PROJECT
TOWNHOME
DEVELOPMENT
140 MILLS ROAD
KELOWNA BC

Date: February 20, 2017
File No.: Z17-0003
To: Urban Planning Management (TB)
From: Development Engineering Manager (SM)
Subject: 140 Mills Road Lot: 3 Plan: 9286 RU1 to RM2

The Development Engineering Department has the following comments and requirements associated with this rezoning application to rezone from RU1 to RM2 to facilitate the development of four townhomes. The road and utility upgrading requirements outlined in this report will be requirements of this development.

SITE PLAN

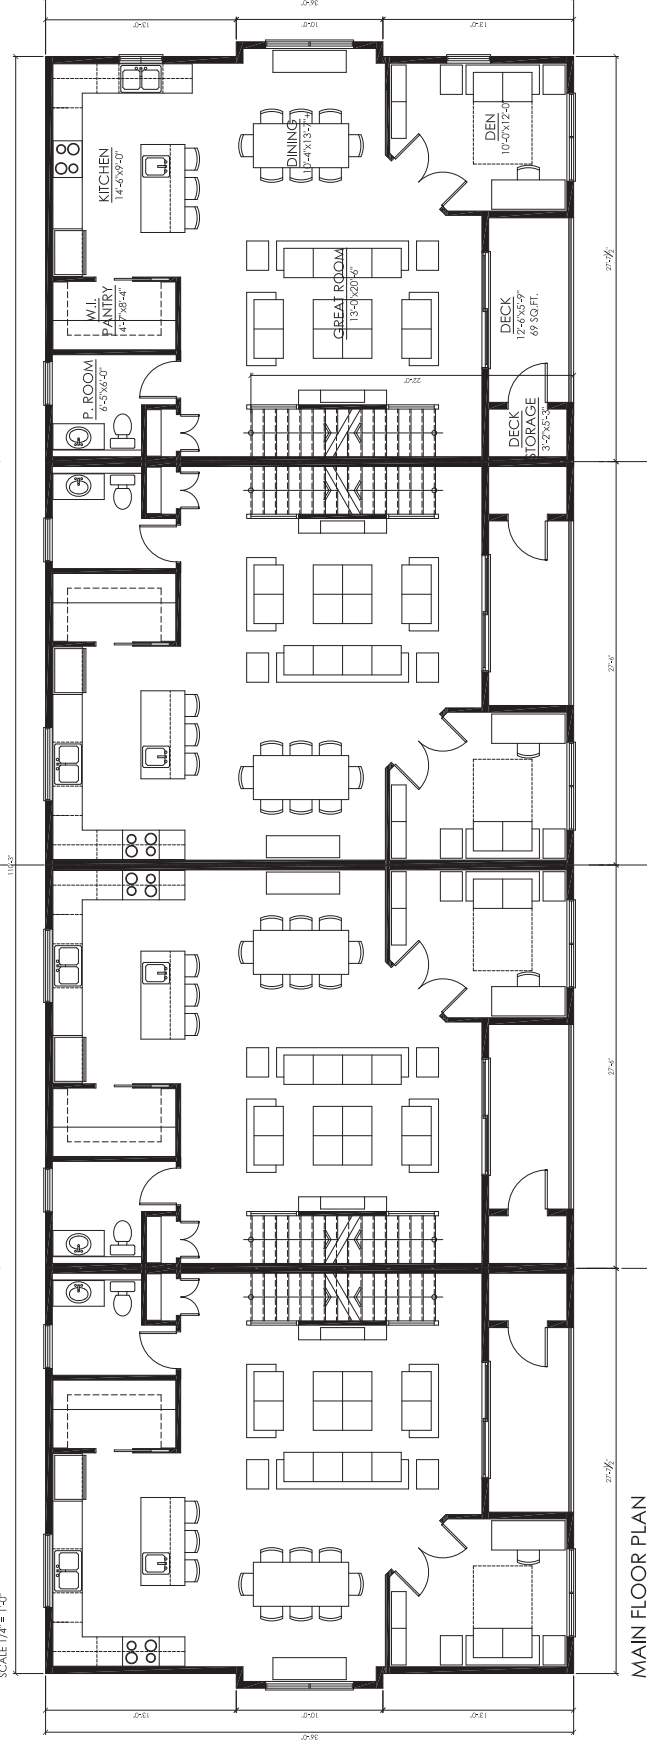
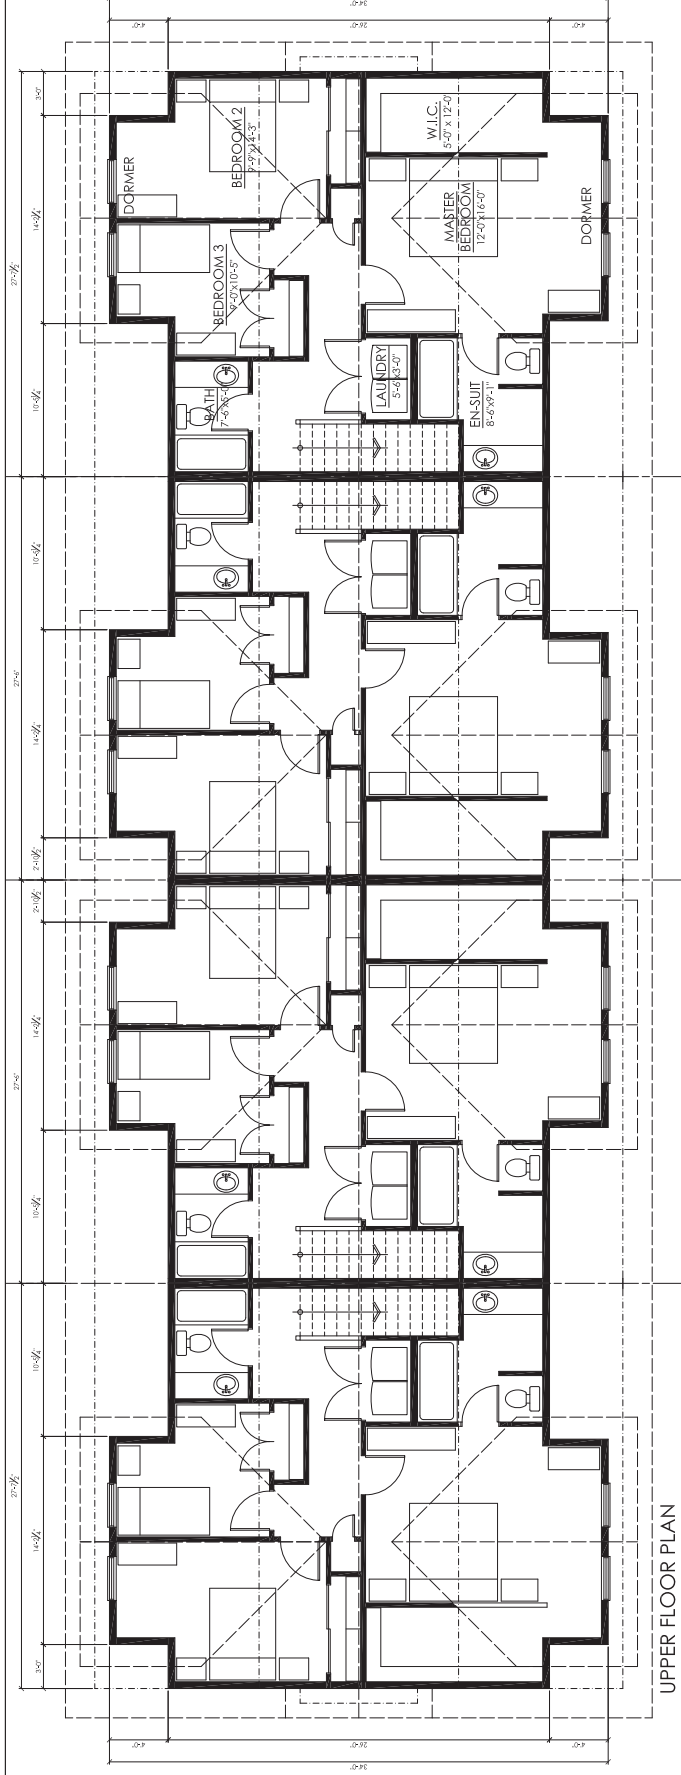
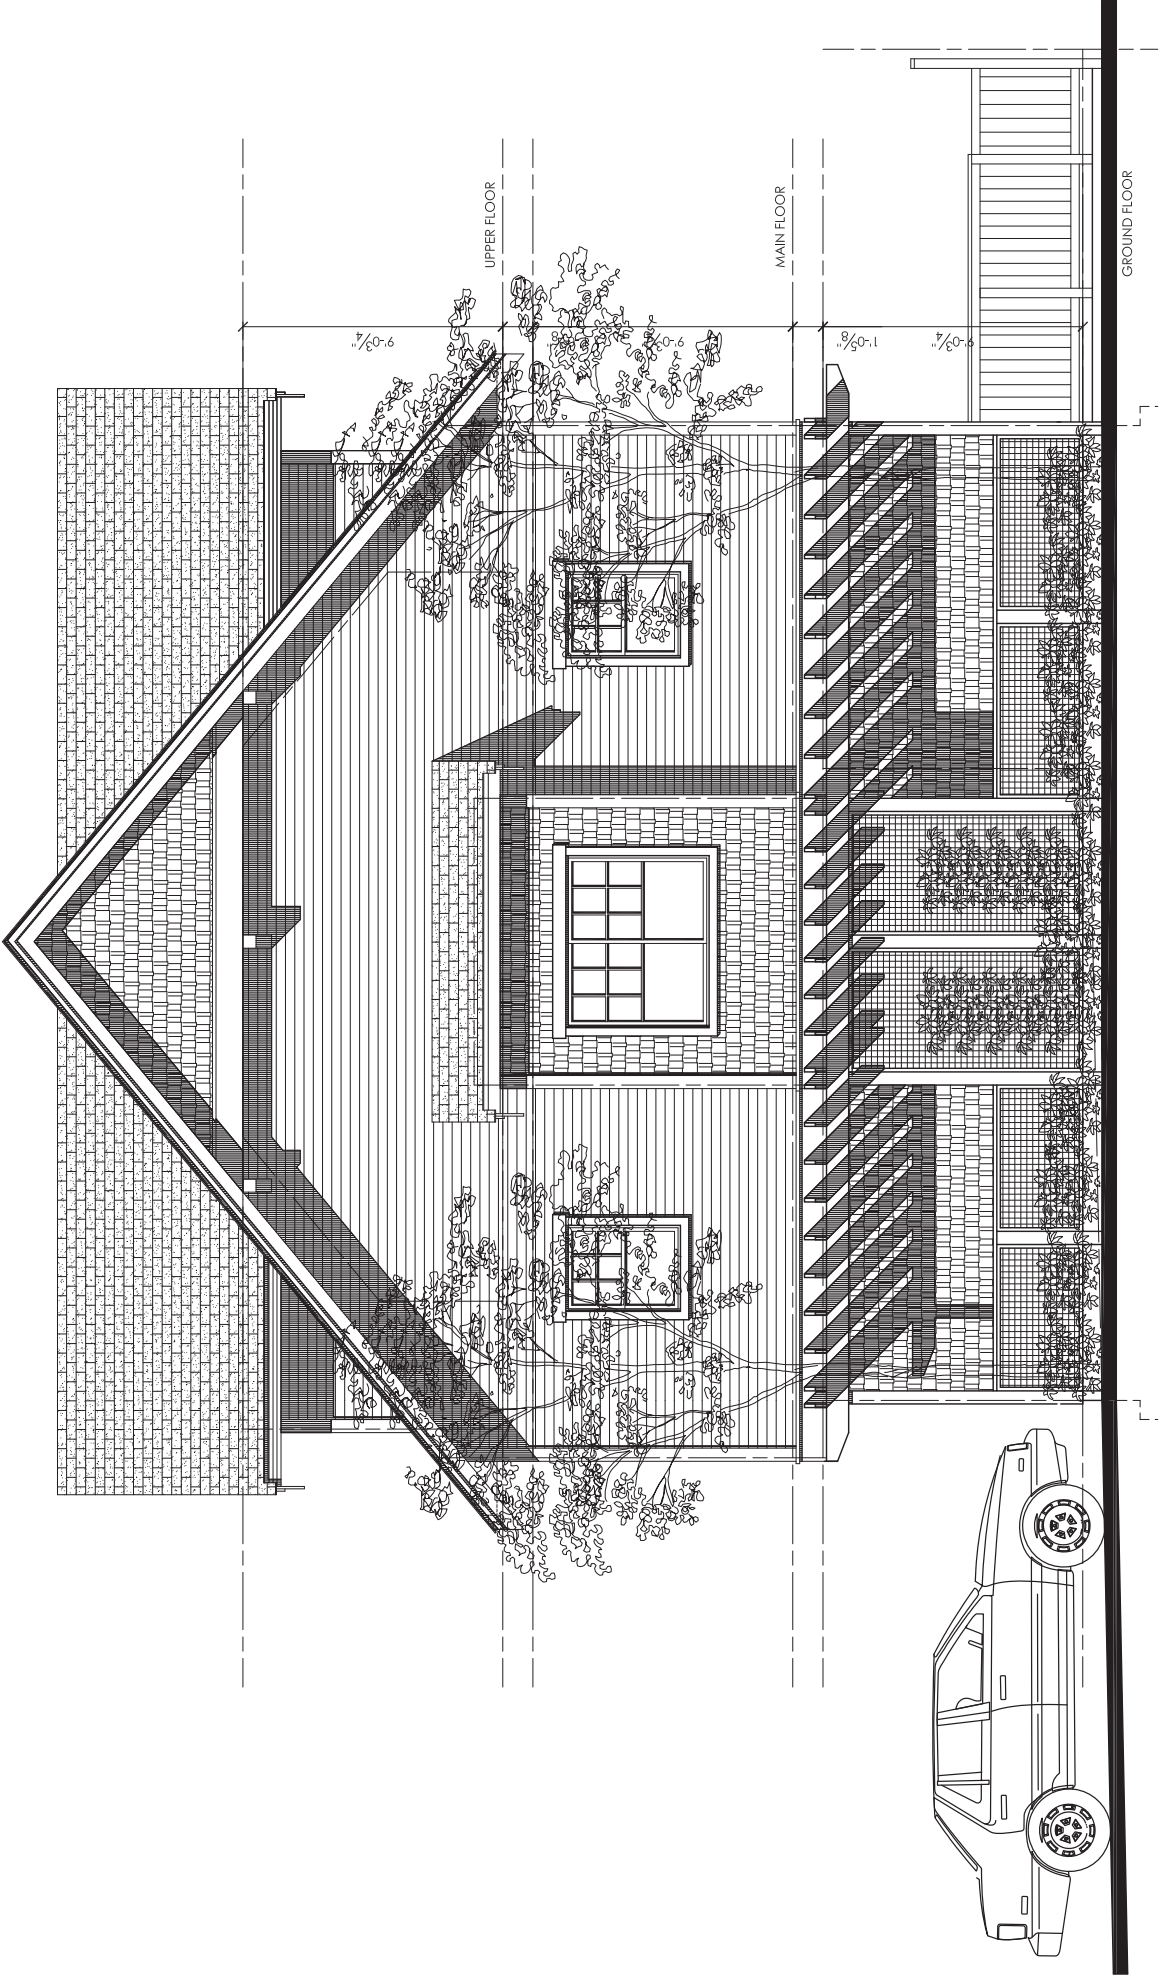
- a) Direct the roof drains into on-site rock pits or splash pads.
- b) An MSU standard size vehicle must be able to manoeuvre onto and off the site without requiring a reverse movement onto public roadways. If the development plan intends to accommodate larger vehicles movements should also be illustrated on the site plan.
